**LEE C. FINE MEMORIAL AIRPORT
CITY OF OSAGE BEACH, MISSOURI**

ADDENDUM NO. 1

State Project No. 20-046B-1

FEBRUARY 11, 2021

2021 ALLOWABLE CONSTRUCTION TIMEFRAMES

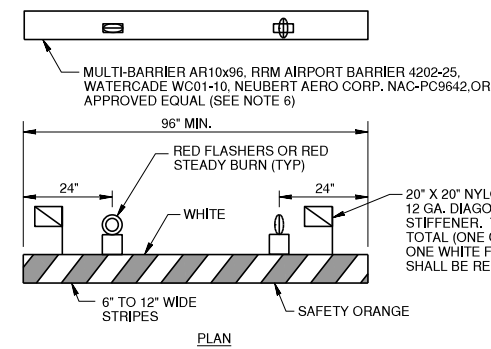
SHEET 8 of 71 – Construction Activity Details Sheet 1

CLARIFICATION: 2021 Allowable Construction Timeframes has been modified to reflect the new, minimum half-apron requirements for the holidays and buffers. Heavy hauling during these buffers will not be allowed, as airport activity will be at a high, and the remaining apron will be in use by aircraft.

20-046B-1
 Sheet 33 of 71
 Drawing: C-1401
 VOL. 1 of 1

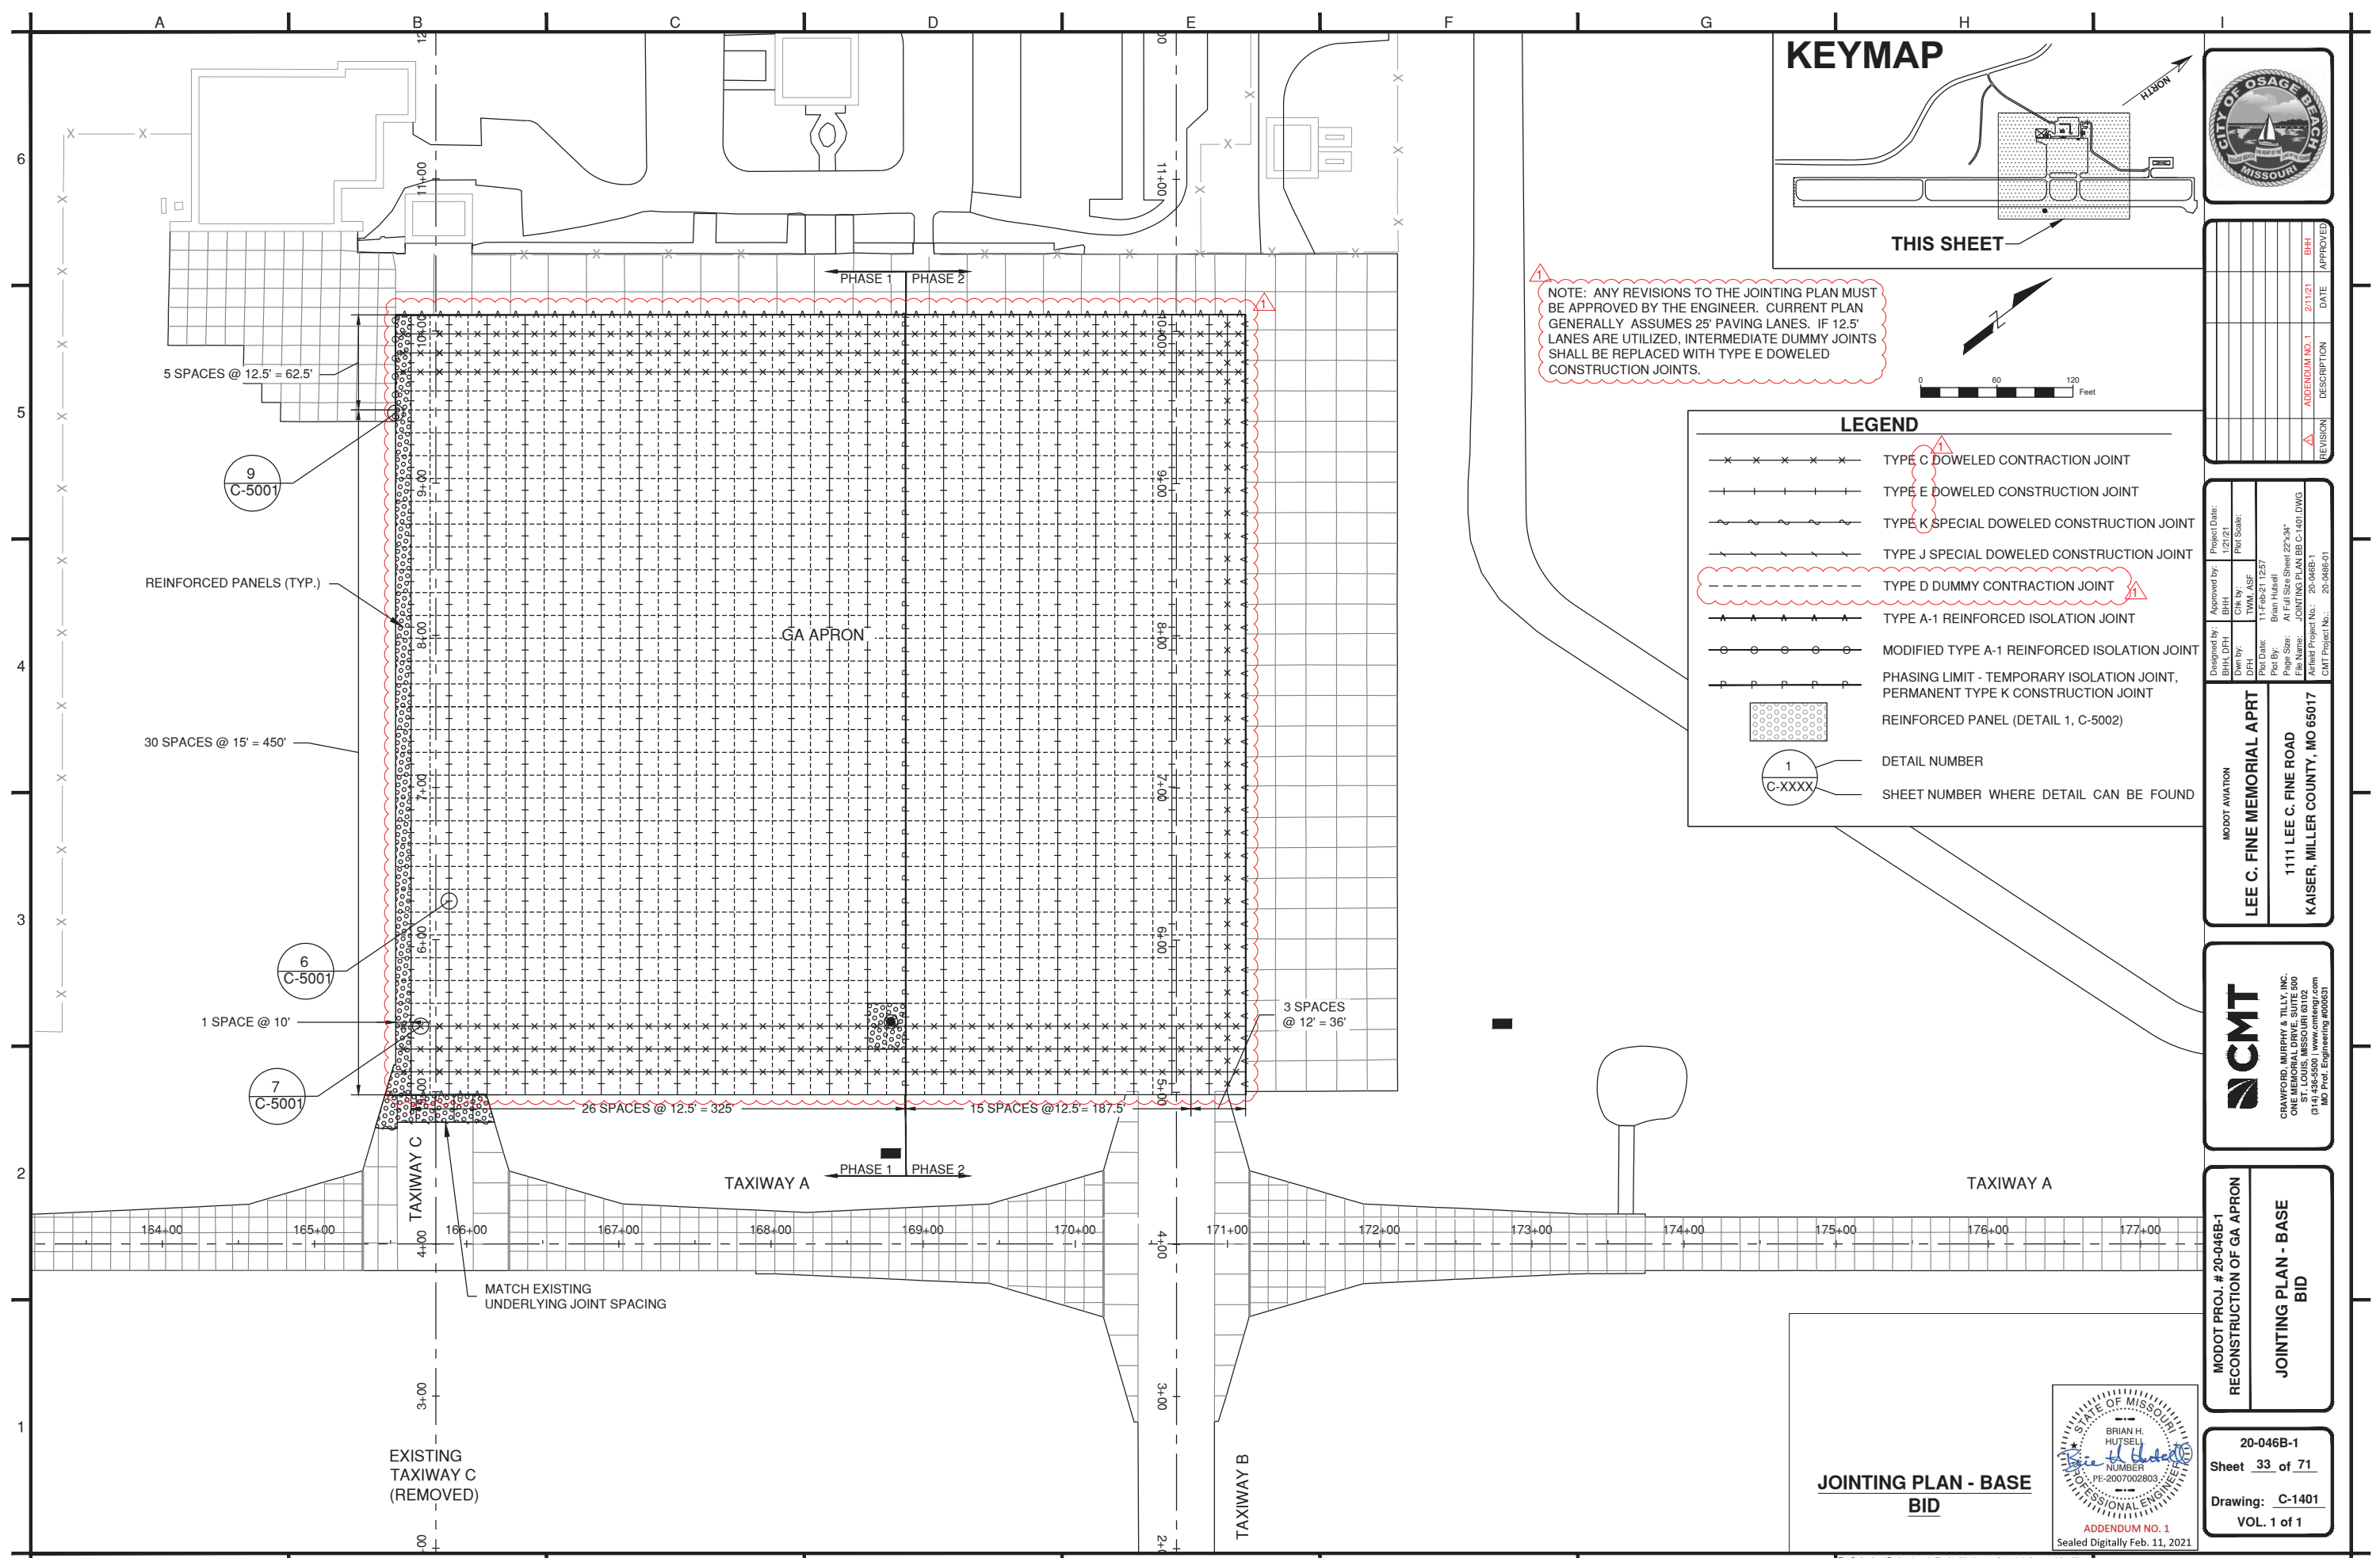
SHEET 33 of 71 – Jointing Plan – Base Bid

CLARIFICATION: Revised sheet reflects 25' paving lanes, and a reduction of transverse panel joint reinforcement and longitudinal joint reinforcement on interior panels. Outer panels will still be doweled or basketed, pending construction method. Note that if paved with 12.5' lanes, dummy joints would be replaced with doweled construction joints for load transfer. Legend revised to include dummy sawed joints, and other jointing types renamed for consistency.

NOTE: ANY REVISIONS TO THE JOINTING PLAN MUST BE APPROVED BY THE ENGINEER. CURRENT PLAN GENERALLY ASSUMES 25' PAVING LANES. IF 12.5' LANES ARE UTILIZED, INTERMEDIATE DUMMY JOINTS SHALL BE REPLACED WITH TYPE E DOWELED CONSTRUCTION JOINTS.

20-046B-1
 Sheet 34 of 71
 Drawing: C-1402
 VOL. 1 of 1

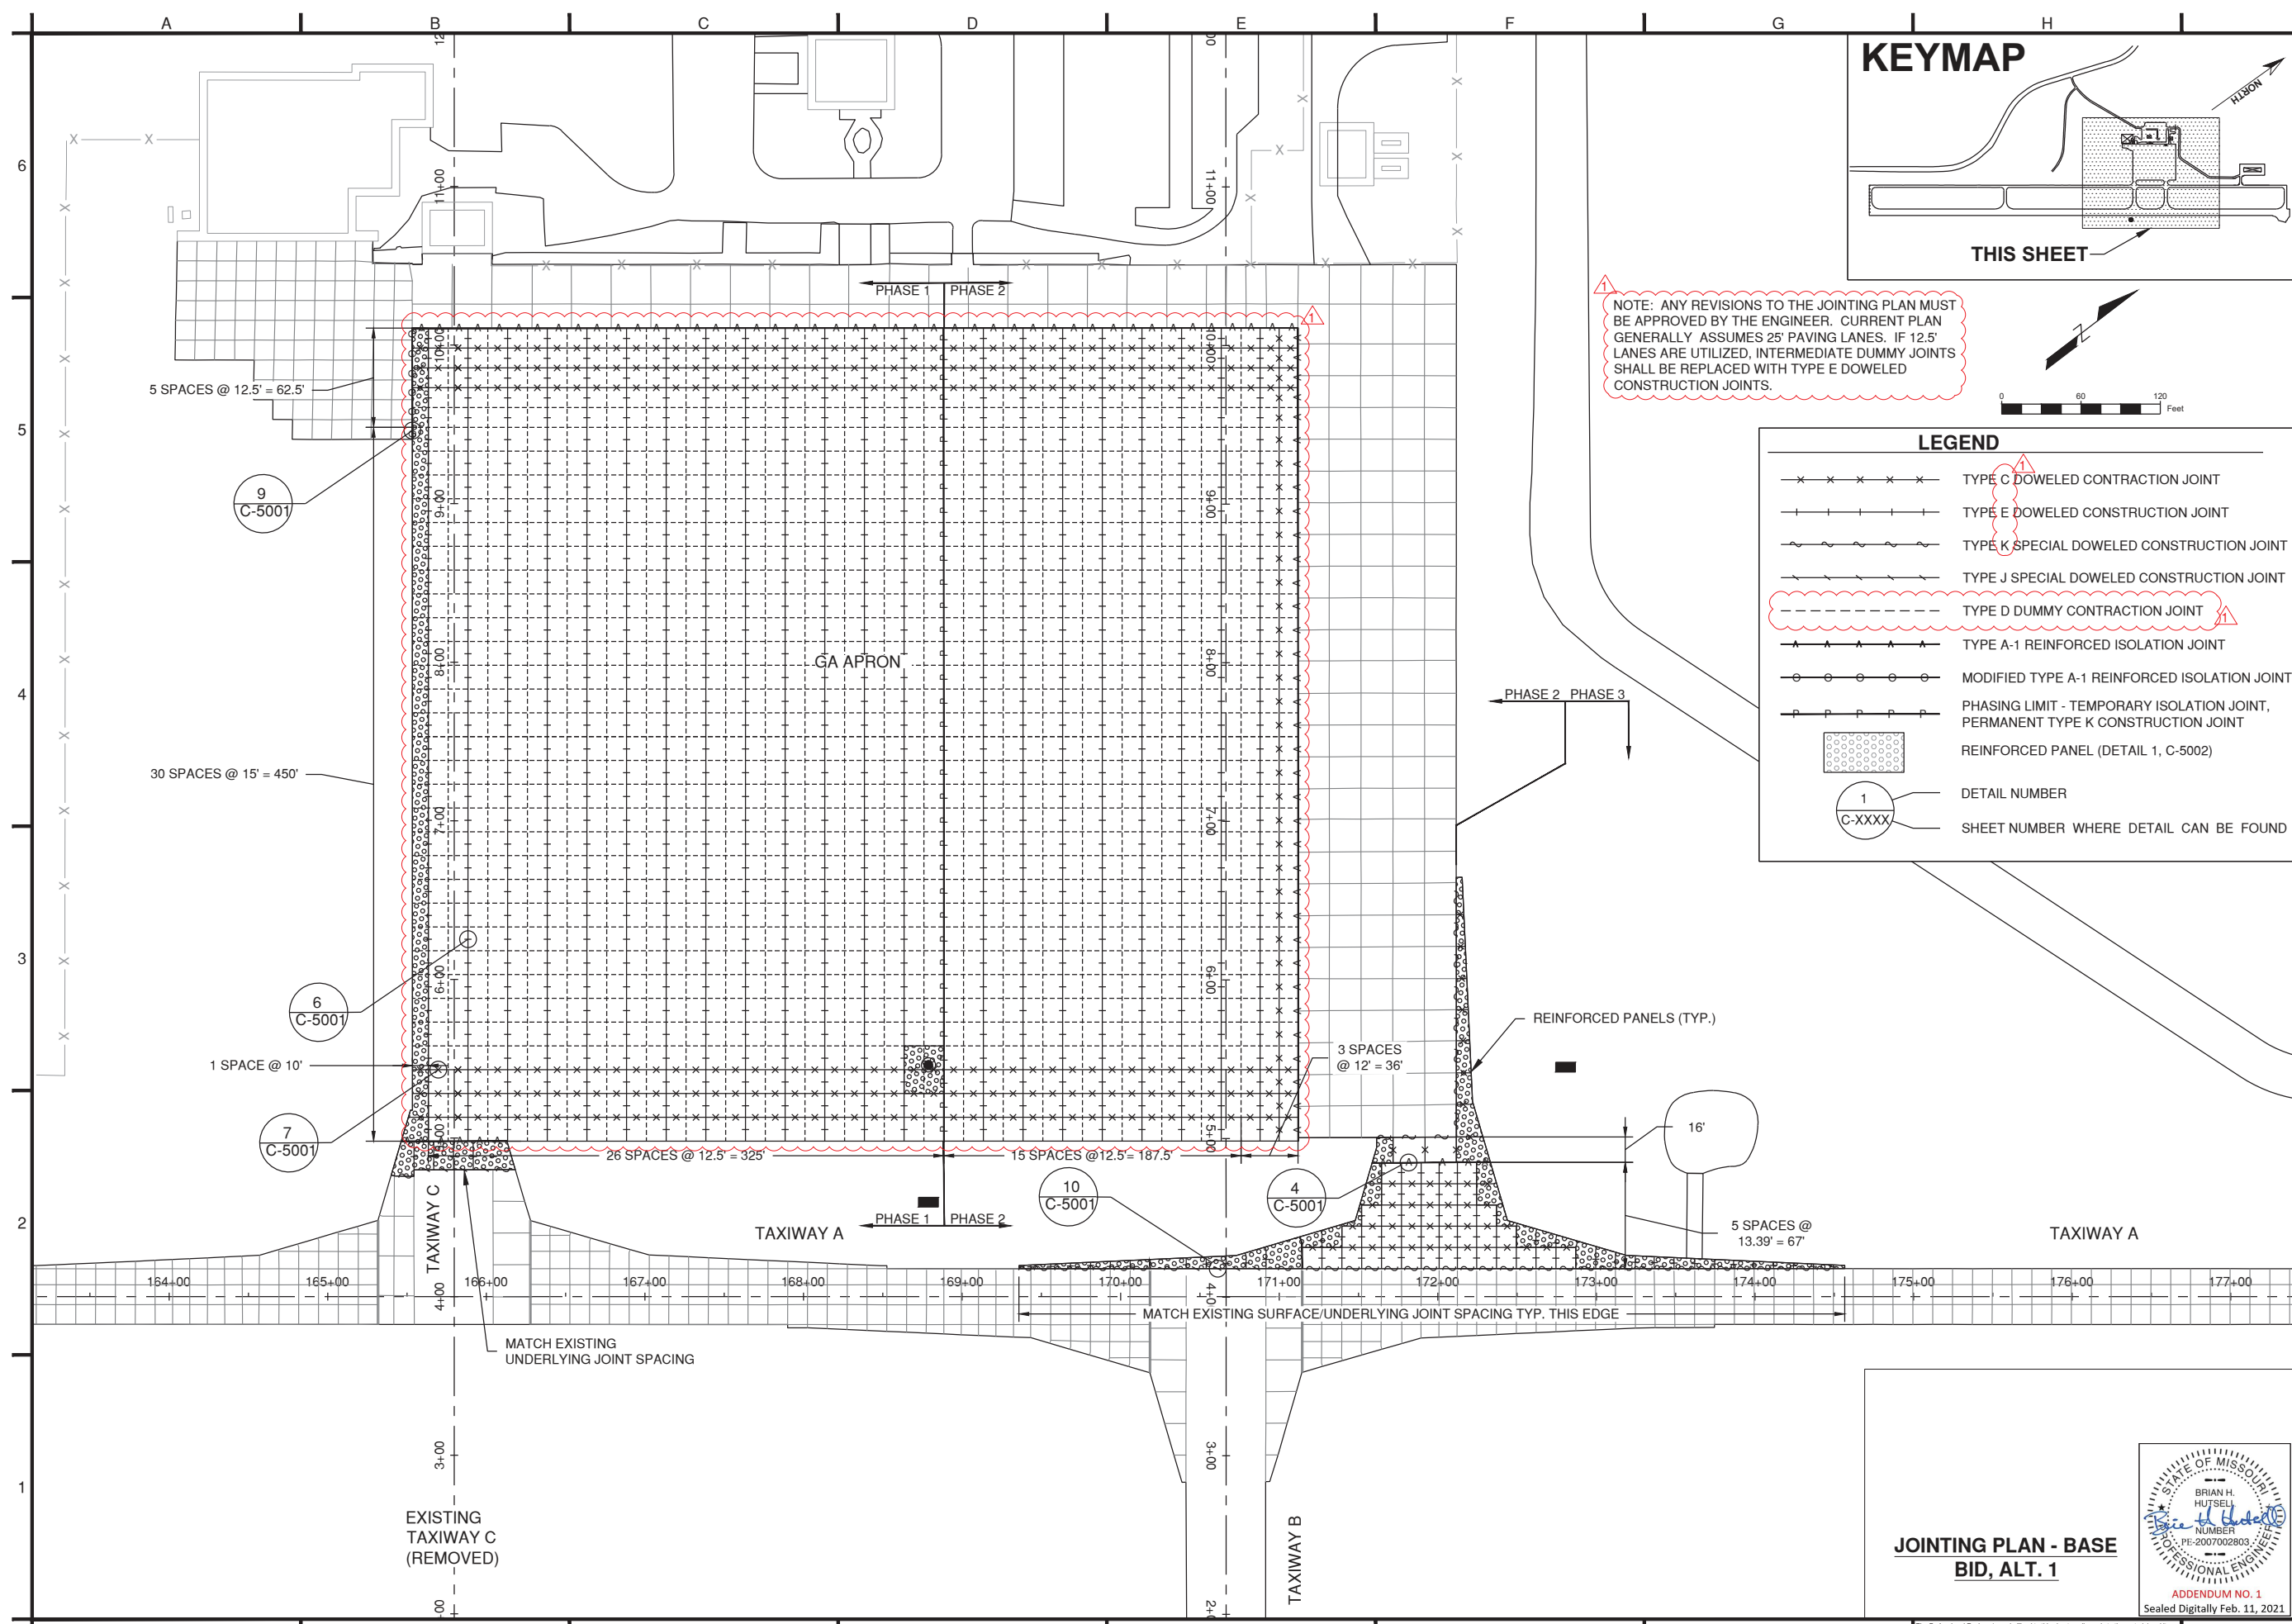
SHEET 34 of 71 – Jointing Plan – Base Bid, Alt. 1

NOTE: ANY REVISIONS TO THE JOINTING PLAN MUST BE APPROVED BY THE ENGINEER. CURRENT PLAN GENERALLY ASSUMES 25' PAVING LANES. IF 12.5' LANES ARE UTILIZED, INTERMEDIATE DUMMY JOINTS SHALL BE REPLACED WITH TYPE E DOWELED CONSTRUCTION JOINTS.
